802.3bj D3.0 sponsor ballot comment i-122

- Supporting presentation D3.0 sponsor ballot comment i-122
- Review achievability of 802.3bj D3.0 mated test fixture specifications.

QSFP28 MTF IL

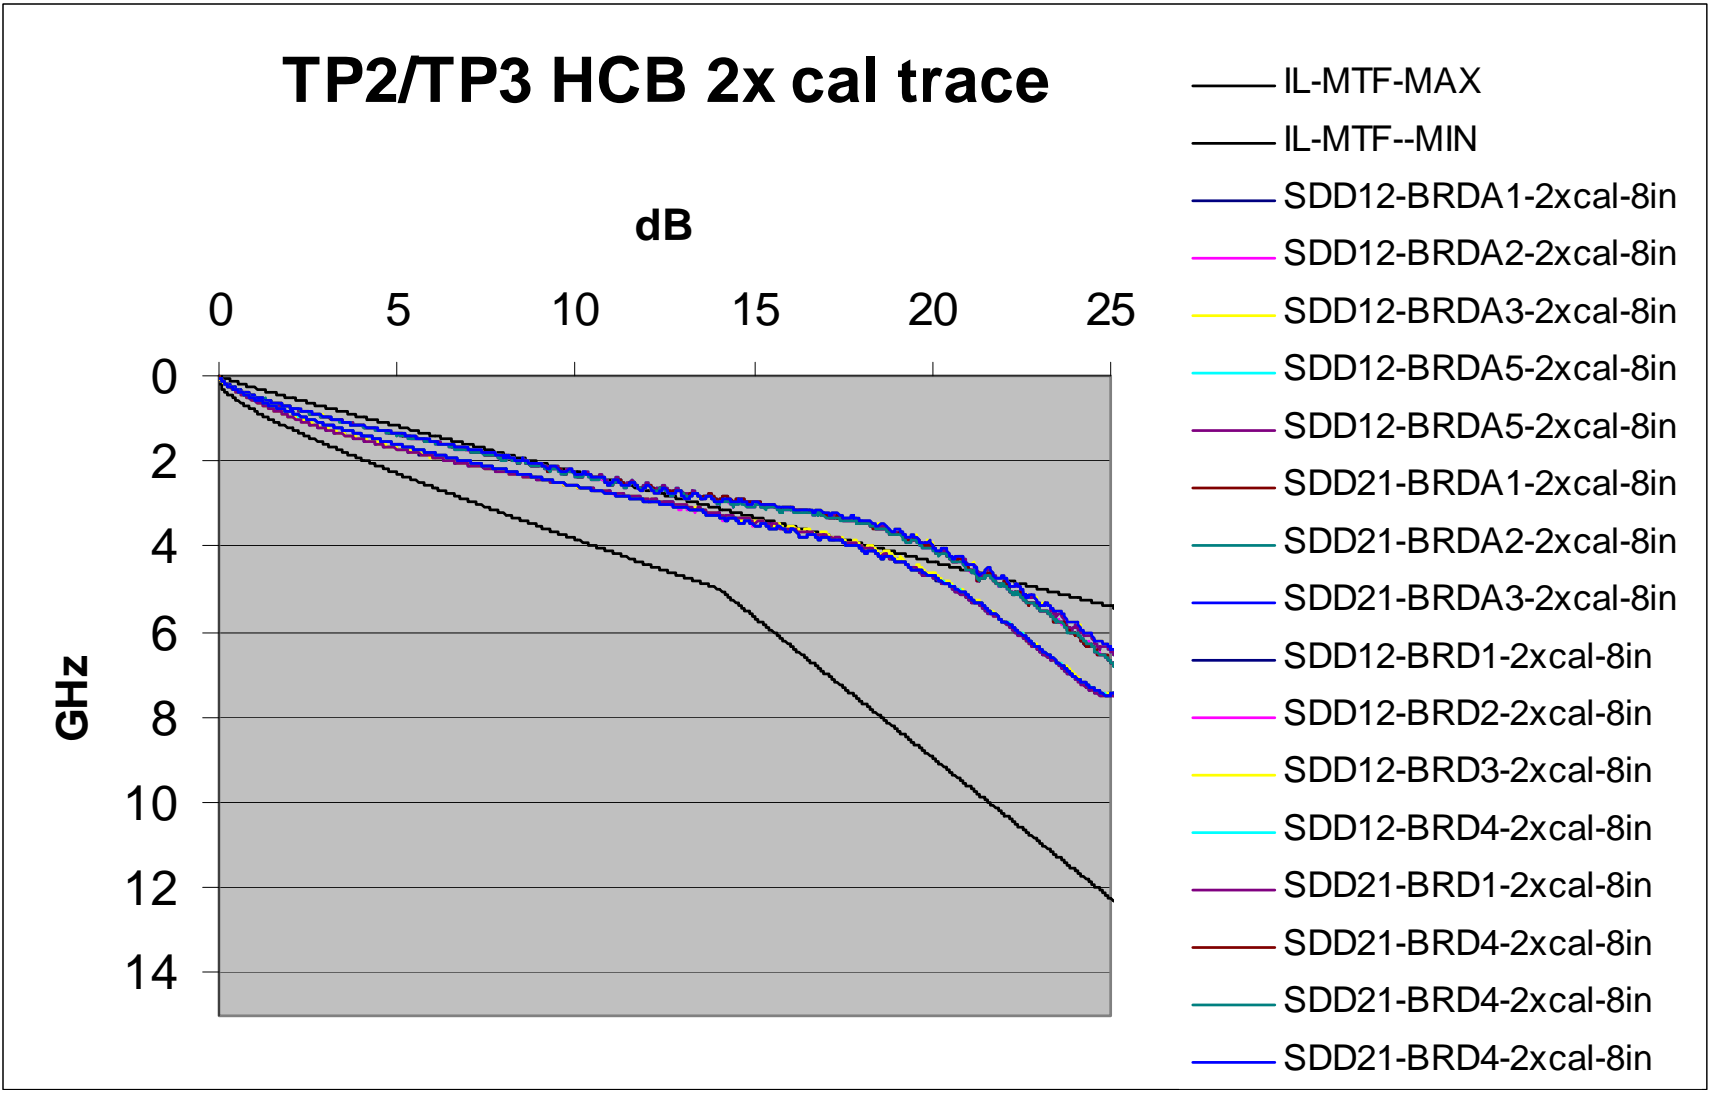
Proposal: $IL(f) \geq IL_{MTFmin} = 0.0656 * \sqrt{f} + 0.164 * f$ $0.01 \leq f \leq 25$ GHz

MTF Insertion Loss

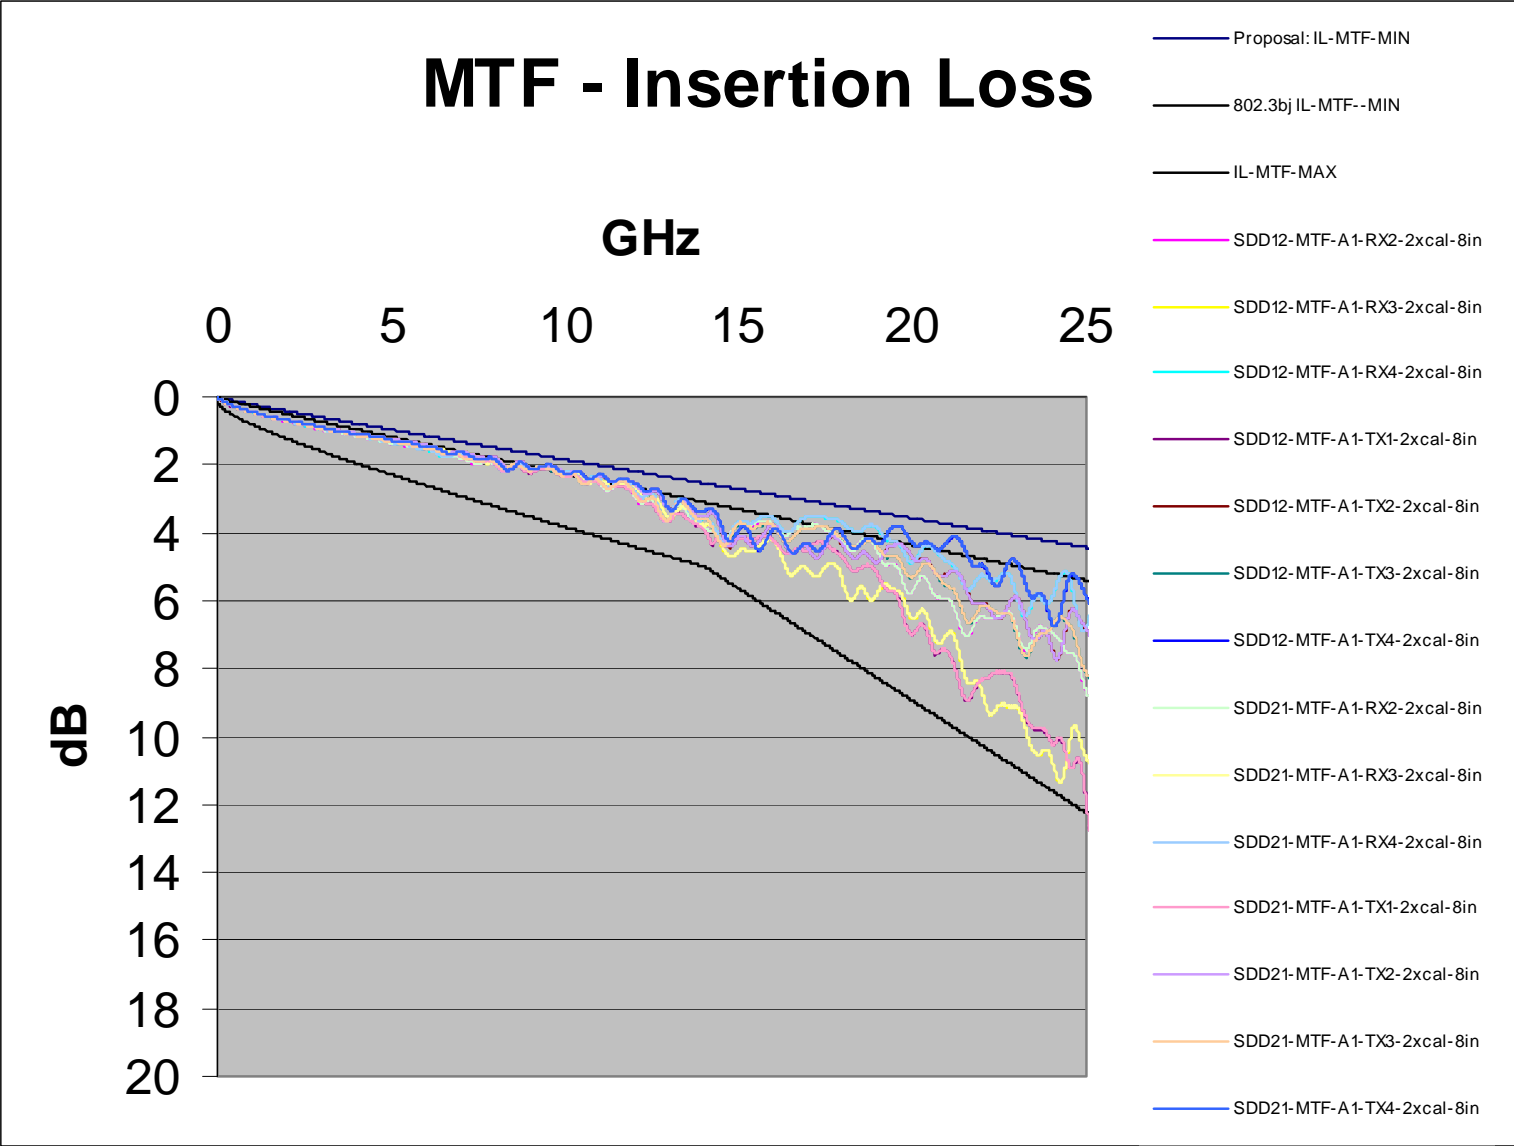
Change (92-44) to:

$$IL(f) \geq IL_{MTFmin} = 0.0656\sqrt{f} + 0.164f \quad 0.01 \leq f \leq 25 \text{ GHz}$$

TP2/TP3 test fixture reference insertion loss proposal

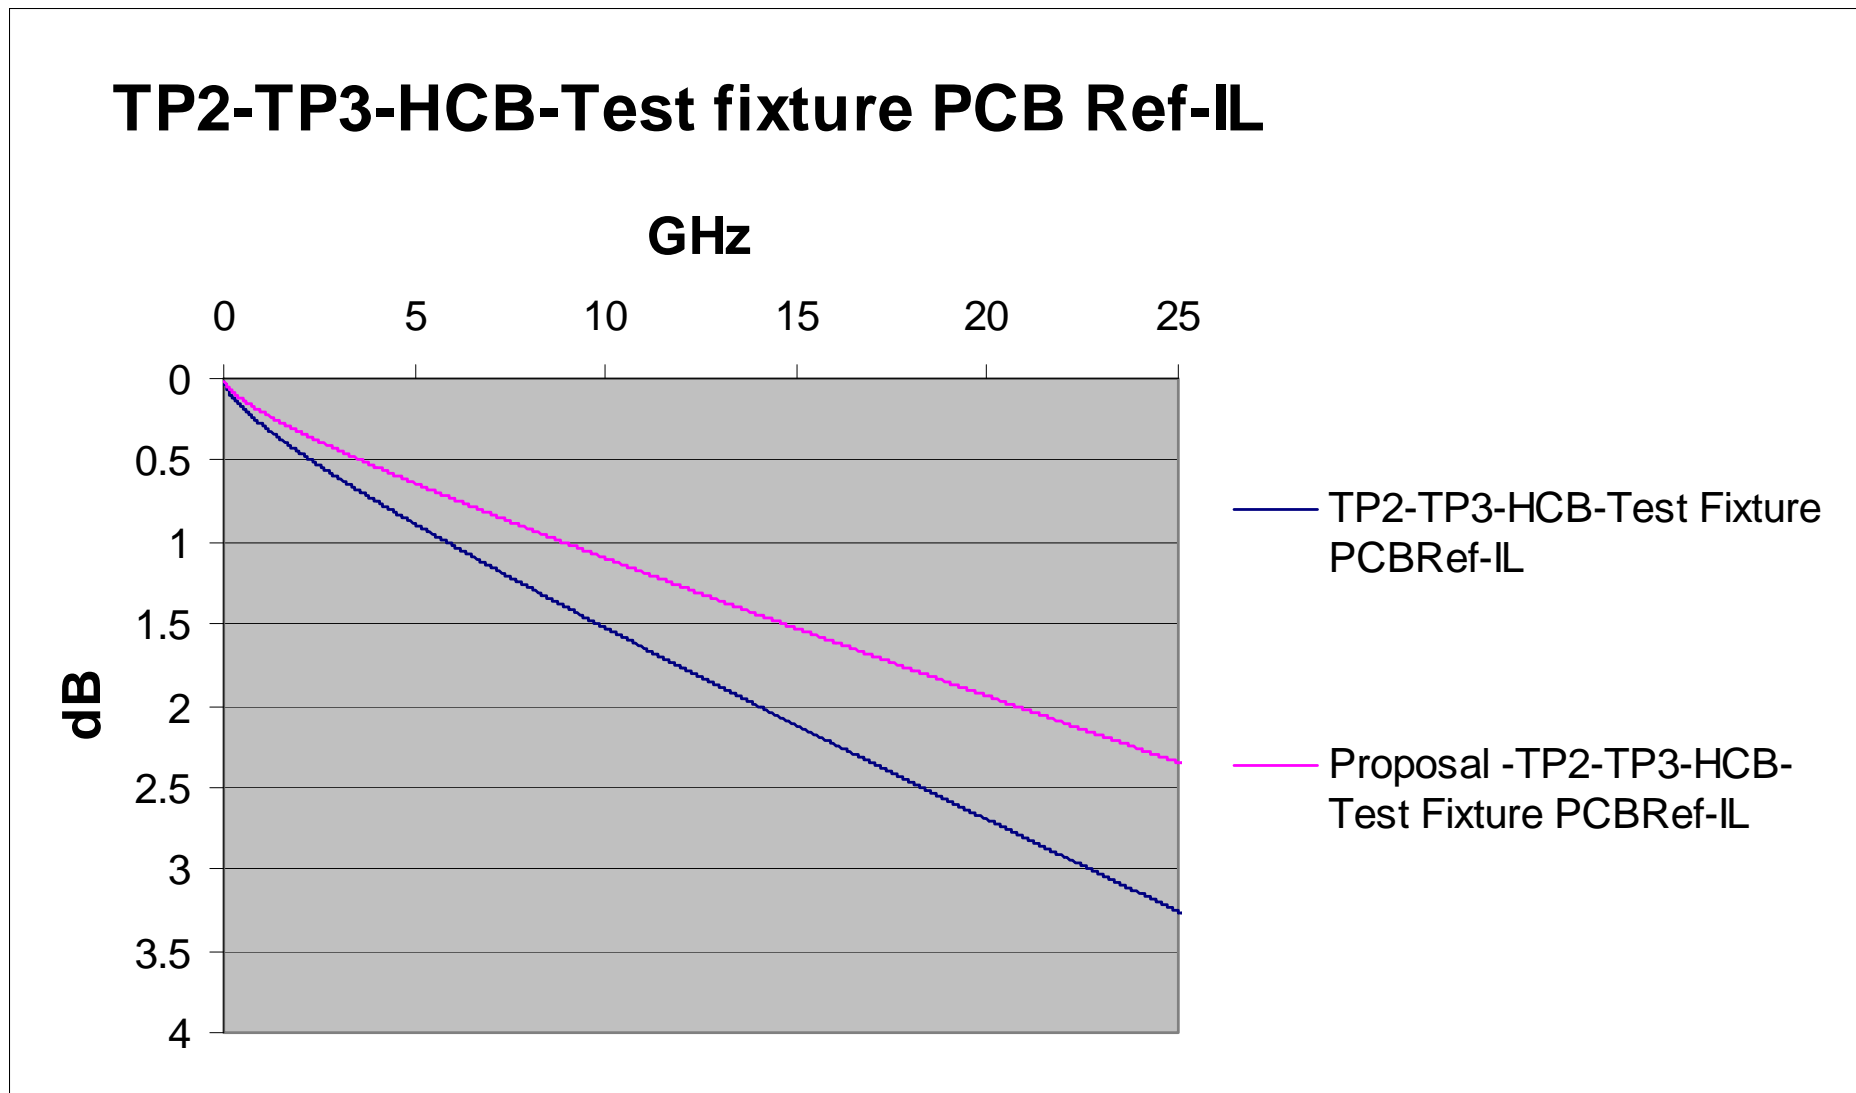
- Change TP2/TP3 test fixture PCB reference insertion loss
- $IL_{\text{tfref}}(f) = -0.00144 + 0.13824\sqrt{f} + 0.06624f$

TP2/TP3 Cal Trace RL

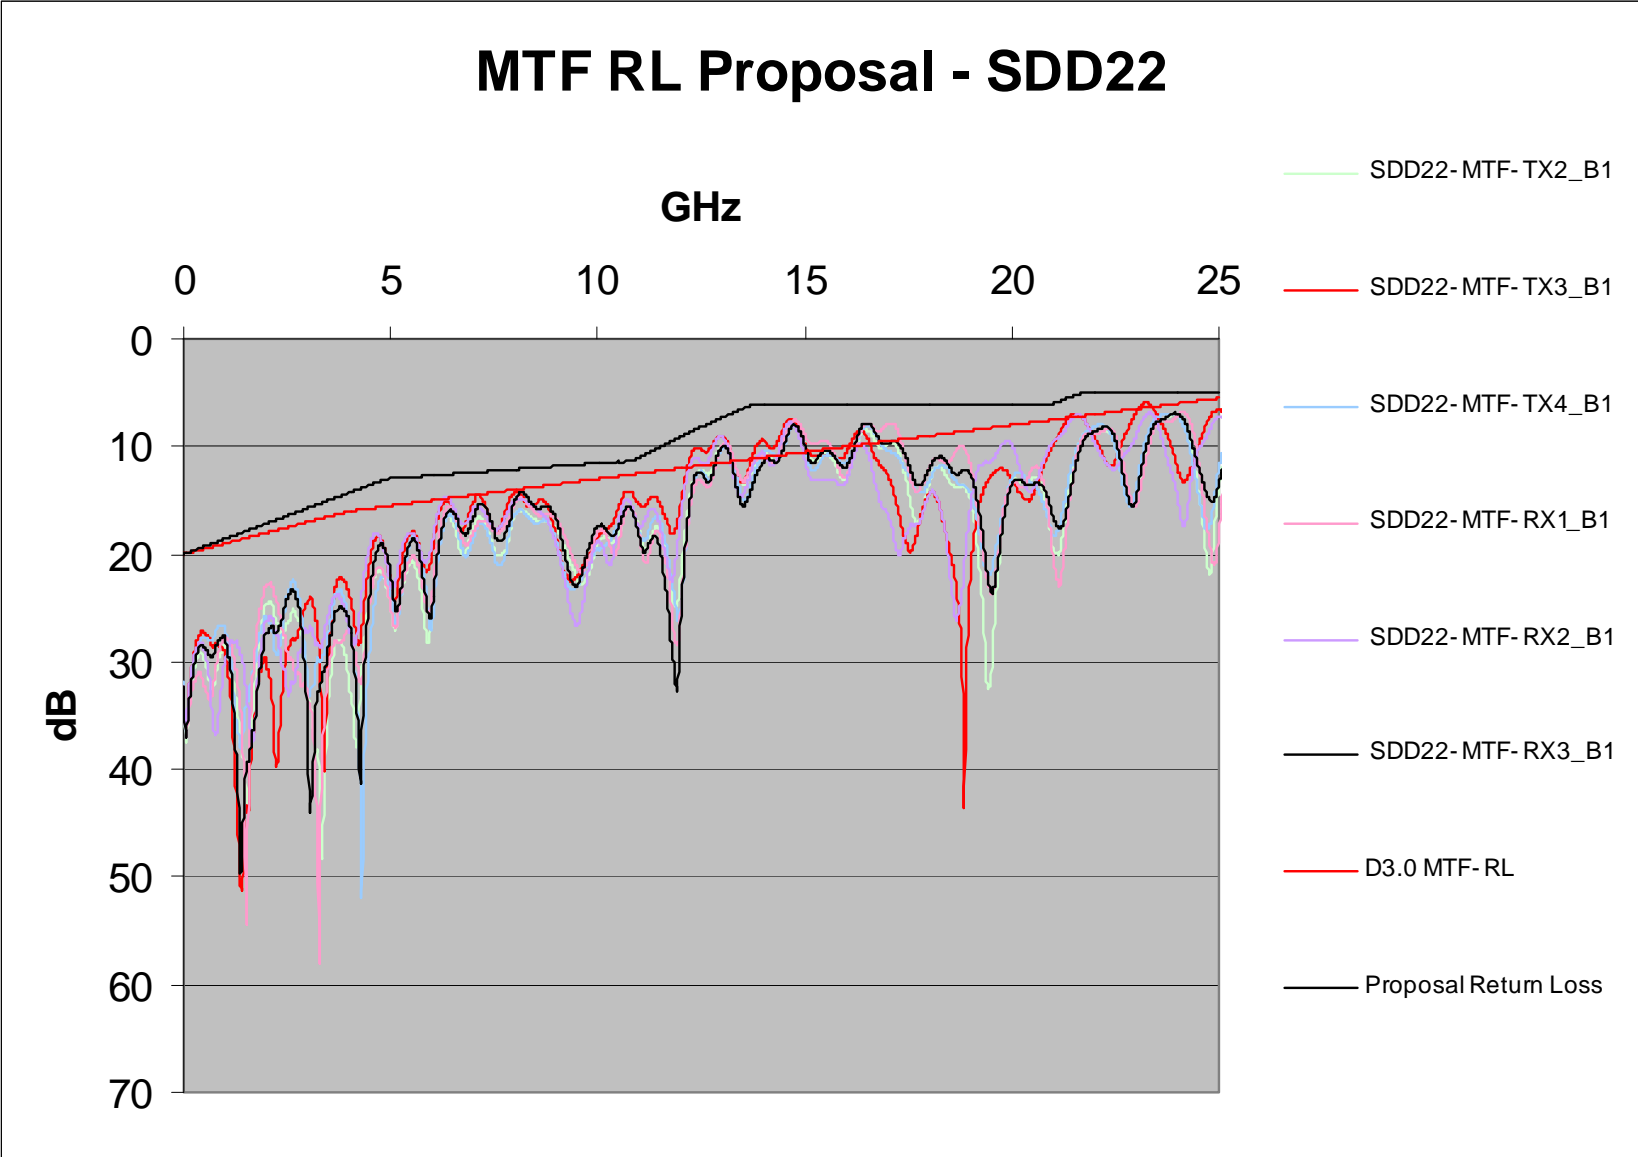
• ***Pessimistic - RLcorrected = RL+2xcal measurement***

TP2/TP3 RL

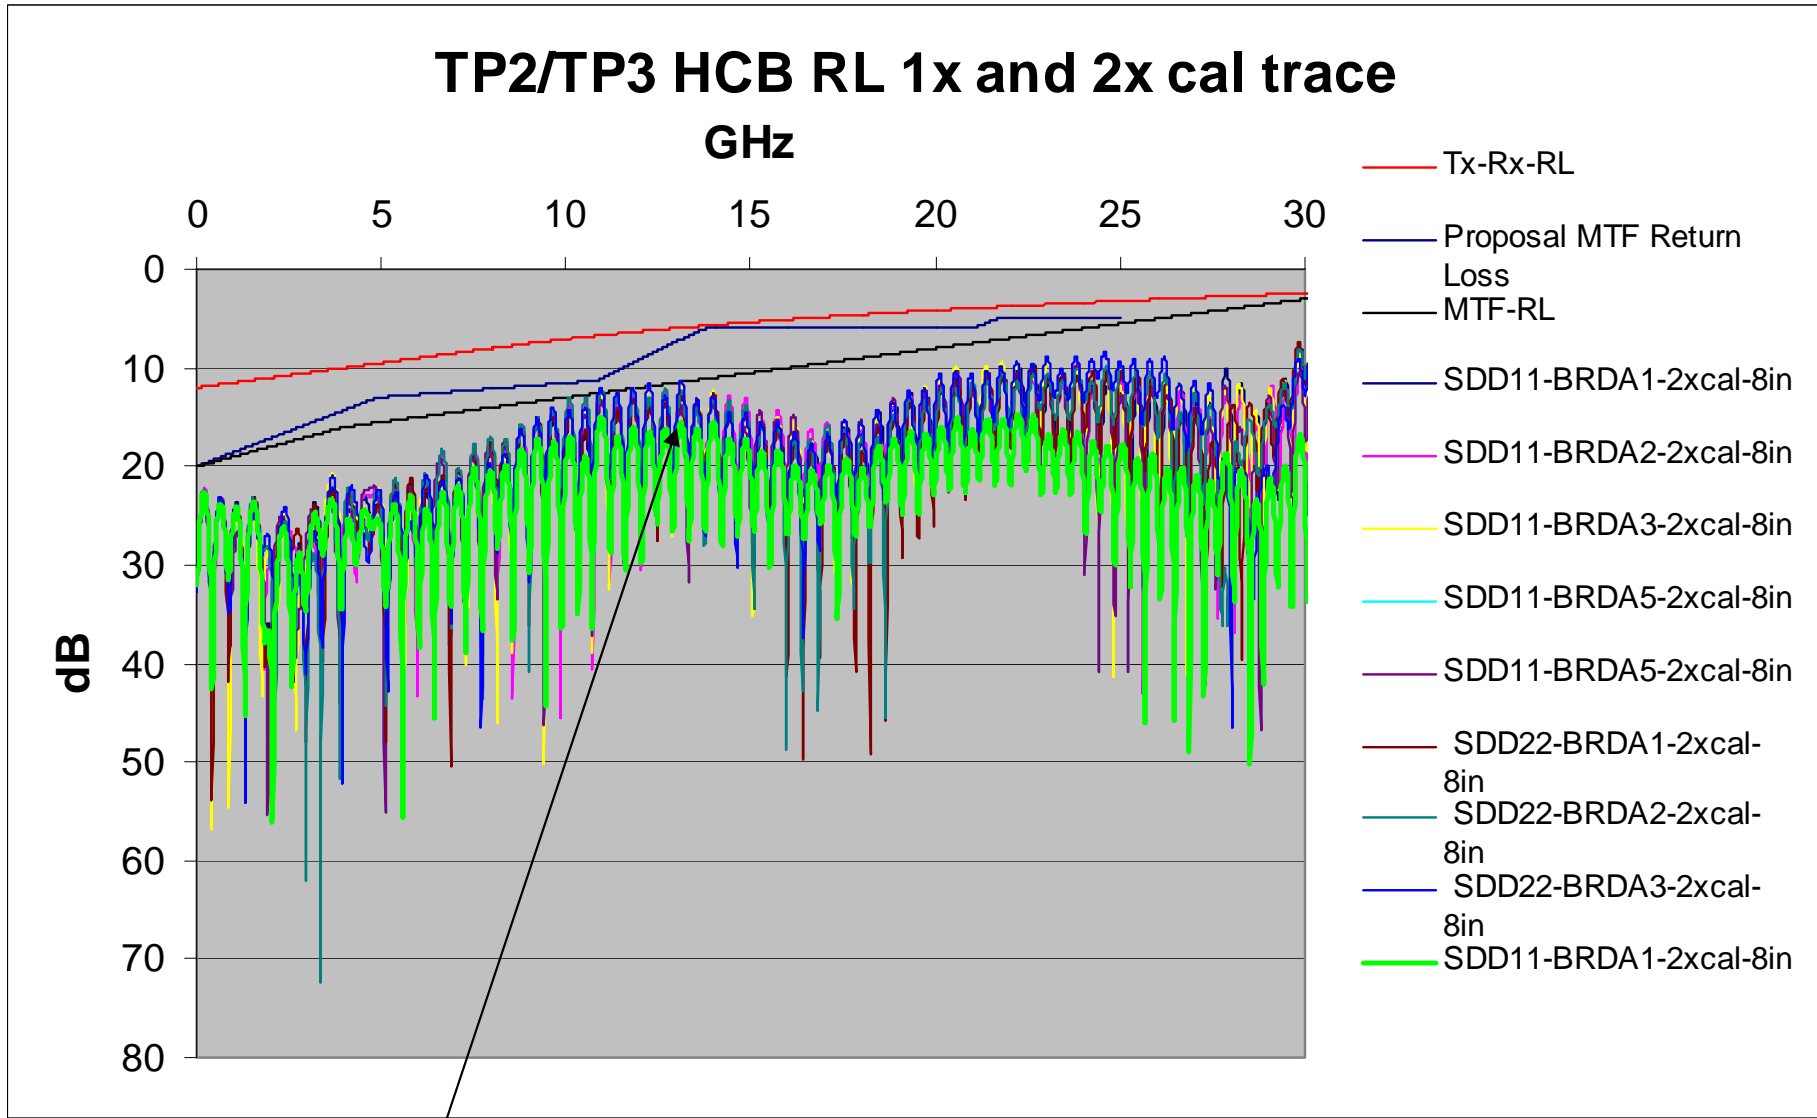
- **Specify TP2/TP3 RL reference using equation below. The MTF RL is specified as proposed slide 21.**

- **Add TP2/TP3 RL specification to 92.11.1 TP2 or TP3 Test fixture**

$$Return_loss(f) \geq \left\{ \begin{array}{ll} 20 - f & 0.01 \leq f < 4 \\ 18 - 0.5f & 4 \leq f \leq 25 \end{array} \right\} \text{ (dB)}$$
